Environmental Review Team Report

Eyles Subdivision

Stonington, Connecticut

January 1985

COASTAL RESOURCES

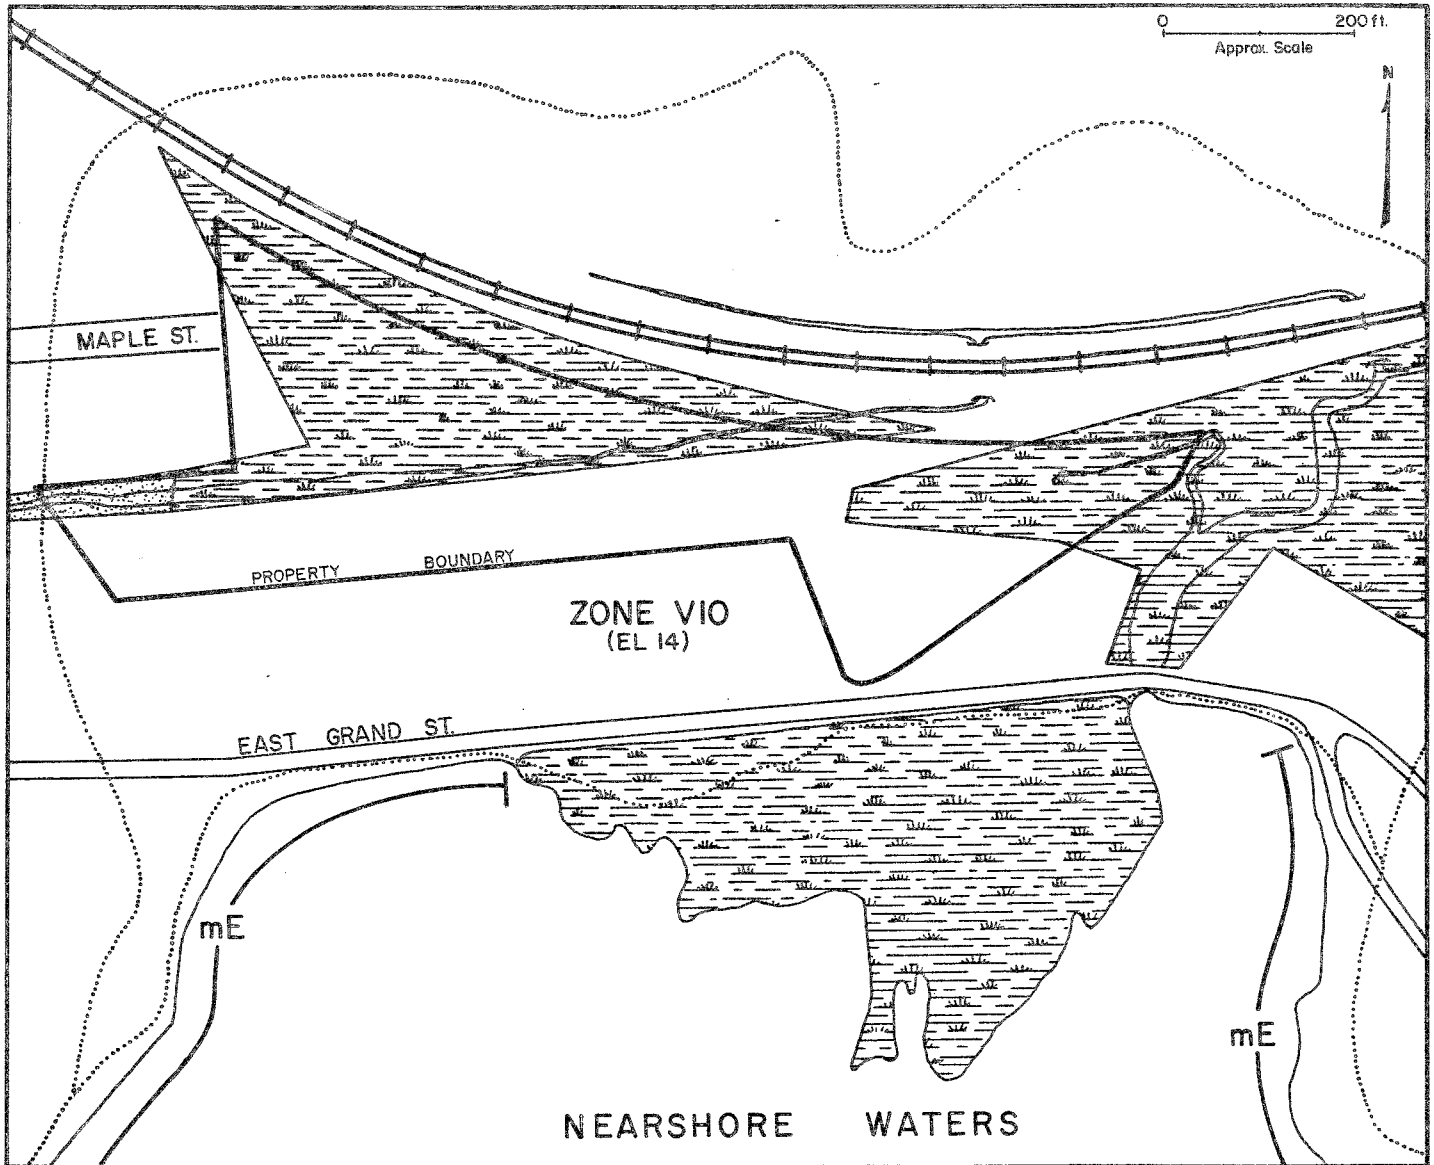
A plan depicting the spatial location of coastal resources on and adjacent to the site must accompany the CSPR application. The CSPR application submitted to the Planning and Zoning Commission lacks such a plan. As defined in the CCMA, coastal resources located on the site include General Resources, Tidal Wetlands, Freshwater Wetlands and Watercourses and Coastal Hazard Area (flood and wave). Also adjacent to and connected to the site via tidal creeks and ditches are coastal waters.

The plan dated October 1984 prepared by DiCesare-Bentley Engineers, Inc. does not delineate the area of state regulated tidal wetland. Rather, the annotations on the plan indicate that tidal wetland lies below contour elevation 3 feet mean sea level (msl). This, however, does not coincide with the area of state regulated tidal wetlands. The regulated wetland area is delineated on an official set of wetland maps (1 inch = 200 feet). The regulated wetland line has been superimposed on the site plan map by Mr. Luzzi. This map serves as a useful guide; however, it would appear that the western boundary of the wetland should be shifted to the east. It also appears that the wetland boundary lines, as they appear on the official tidal wetland map, are not accurately located. For this reason, we strongly urge the applicant or the Planning and Zoning Commission to request that the wetland boundary be flagged in the field by the Water Resources Unit of the Department of Environmental Protection. Once this is accomplished, then the wetland boundary can be transferred to the site plan to allow for a more precise elevation of wetland impacts. Despite the minor problems with the Luzzi map, it clearly shows that tidal wetland occurs above elevation 3' msl. Also, this map has been used as a guide to determine the general nature of wetland impacts and wetland acreage associated with the proposed subdivision.

The designated tidal wetland boundary crosses the ditch in the vicinity of Lot #2. The open ditch to the west of this line should be considered a watercourse and is therefore subject to the provisions of the Inland-Wetland and Watercourses Act (C.G.S. 22a-36 to 45). Any associated wetland that is not regulated tidal wetland, would also be subject to the provisions of this Act. The applicant must therefore apply for local inland wetland permits for the proposed activities in this watercourse. Under the provisions of the CCMA, this area is considered Freshwater Wetlands and Watercourses.

The Coastal Hazard Area, as determined by the Federal Emergency Management Agency (FEMA), includes two subelements; namely, flood hazard and wave hazard area. The entire project site and the roads leading to it are classified by FEMA as a "V-zone" (coastal high hazard area). Such areas would be subject to flooding during a 100 year coastal storm event and would further be subject to wave action. The 100 year flood elevation for this site is 14 feet National Geodetic Vertical Datum (NGVD) as delineated on the FEMA Flood Insurance Rate Maps.

EXTENT OF TIDAL WETLANDS IN 1882 - 1883

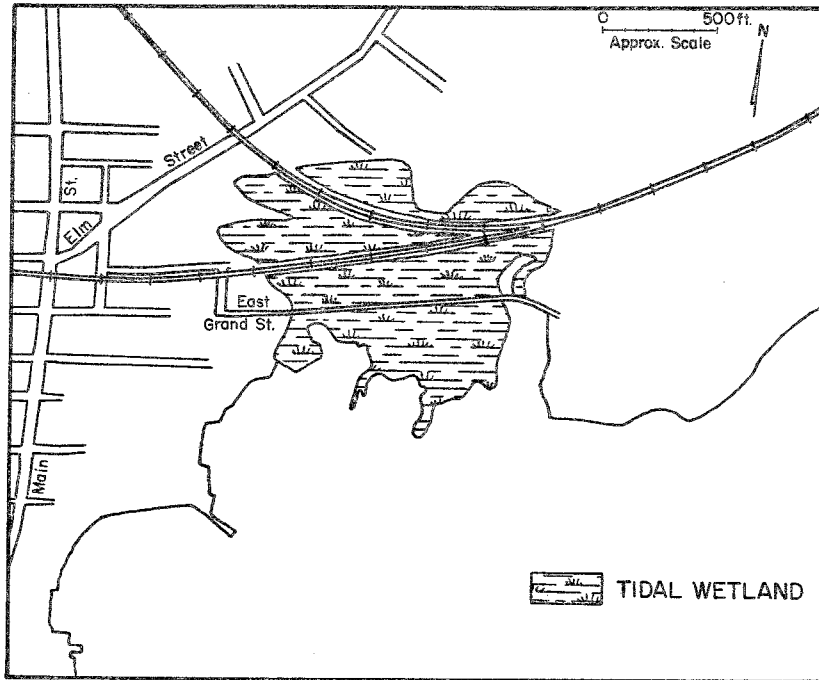
4. Require soil borings to determine the suitability of the soil substrate for building foundations (pile type). It should be noted that an old Coast and Geodetic Survey map for this area (circa 1882-83) illustrates that wetland peat exists under the entire project site. This creates an unstable substrate. This condition will require that pile supported construction practices be used or that the peat be excavated and backfilled with appropriate material. It would be advisable for the Planning and Zoning Commission to request that soil borings be conducted on each lot to determine the depth of peat and depth to stable substrate. With this information, it would be possible to assess the feasibility of building on site. The settling of the neighboring and newly constructed residential structure is a good indication of the severe site constraints. It is also recommended that this information be clearly indicated on the subdivision plan so that when the lots are sold, the purchaser is fully aware of the site limitations.
